Office Action Summary

09/818,470

POOLE, MARK E.

DETAILED ACTION

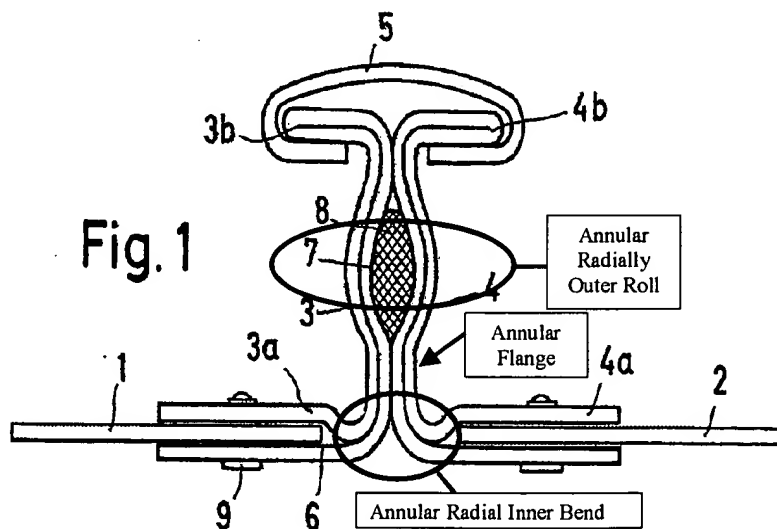
Claims 1, 2 and 4 are rejected under 35 U.S.C. 102(b) as being anticipated by DT 1212356.

In regards to claim 1, in Figure 1 below, DT 1212356 discloses an apparatus for connecting and sealing duct sections, the apparatus comprising:

(A) first and second connectors (3, 4), each connector comprising:

(a) a tubular member (3a, 4a);

(b) an annular flange, extending radially outwardly from an outer end of the tubular member; and

(c) a rolled edge, comprising:

(i) an annular radially inner bend, attached to the outer perimeter of the annular flange;

(ii) an annular radially outer roll, adjacent to the radially inner bend;

(iii) an annular rounded perimeter (3b, 4b), adjacent to the annular radially outer roll and at the outer perimeter of the annular flange, the annular rounded perimeter is rounded inwardly, toward the outer end of the tubular member; and

(iv) whereby a tube cavity is defined within the annular radially outer roll and annular rounded perimeter (minute clearance between the two elements);

(B) whereby an excess duct sealer trough (7) is defined between rolled edges of the first and second connectors; and

(C) a plurality of fasteners (5) connecting the annular flange of the first connector to the annular flange of the second connector.

In regards to claim 2, DT 1212356 discloses a gasket (8), carried between outer annular surfaces of the annular flanges of the first and second connectors, the gasket having a first side surface directed toward the outer annular surface of the first connector and a second side surface directed toward the outer annular surface of the second connector.

In regards to claim 4, DT 1212356 discloses a duct sealer (8), carried firstly between the annular flange of the first connector and the annular flange of the second connector.
